Application by Elements Green Trent Limited: Great North Road Solar and Biodiversity Park (Application Reference: EN010162) - Responses to Secretary of State's Request for Information

Table 1 Applicant's Responses to the Secretary of State's Request for Information

Figure 1: Extract from ES Volume 3, Figure 5.1: Works Areas [EN010162/APP/6.3.5D] [REP5-015] (Grey – GNR Intermediate Substation; Green - Mitigation/Enhancement; Blue – Solar PV).

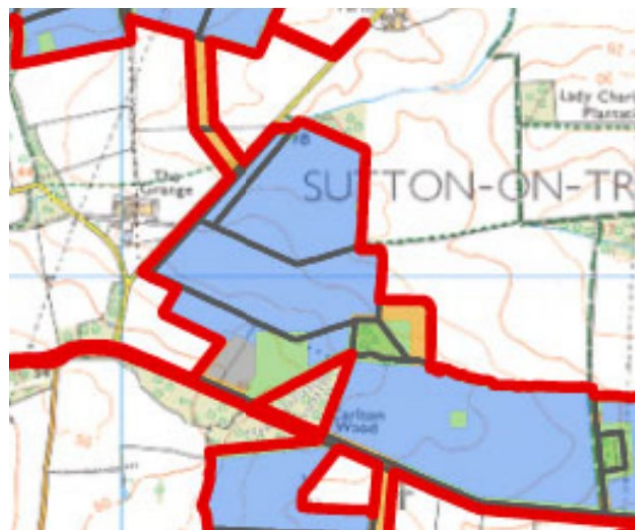
14	The Applicant is requested to provide details of the site selection process and consideration of alternatives for intermediate substations [PIR-003].	The intermediate substation in question is the proposed Ossington Road Intermediate Substation which forms part of Work No. 4 (Intermediate Substations) and is shown on the Works Plans [EN010162/APP/2.3A] [AS-005], Sheet 31. For ease of reference, the proposed Ossington Road Intermediate Substation is referred to as the "GNR Intermediate Substation" in this response. The GNR Intermediate Substation is located along Ossington Road, to the south of the proposed solar arrays. It is situated to the west of the ecological enhancement area, which essentially extends north-east from Carlton Wood.
----	--	---

ES Volume 2, Chapter 8: Ecology and Biodiversity [EN010162/APP/6.2.8D] [REP6-019] confirms that the Proposed Development would not result in any significant effects on Carlton Wood and the ancient woodland. Please refer to the Applicant's responses on the biodiversity effect on Carlton Wood within Table 3-3 of the **Responses to Deadline 3 Submissions** [EN010162/APP/8.29] [REP4-059], at pages 19 and 20. The Applicant would like to reiterate that there are no physical works proposed at Carlton Wood, nor within the ancient woodland, and **ES Volume 4, Appendix A5.3: Outline Construction Environmental Management Plan (CEMP)** [EN010162/APP/6.4.5.3E] includes a commitment to maintain a 15m buffer from the woodland boundary to ensure that there are no unacceptable effects on the ancient woodland.

The Applicant does not agree with the Parish Council's suggestion of co-locating the GNR Intermediate Substation with the existing Carlton Substation. The existing Carlton Substation functions as an electricity distribution substation, which distributes energy coming from the grid to users. Whereas, the GNR Intermediate Substation serves a different purpose. As described in Section 6.2.4 of the **Design Approach Document [EN010162/APP/5.6B]** [\[REP2-019\]](#), the GNR Intermediate Substation will transport energy generated by the Proposed Development to the GNR 400kV Substation and then to the grid connection point at Staythorpe. Co-location would not be feasible as the GNR Intermediate Substation must be functionally connected to the solar PV areas and associated cable routes.

This iterative design process, as described above, resulted in the current locations of the four intermediate substations shown on the **Works Plans [EN010162/APP/2.3A]** [\[AS-005\]](#). The final location of the GNR Intermediate Substation was therefore a result of an iterative design process, which took into account both technical requirements, environmental and community considerations.
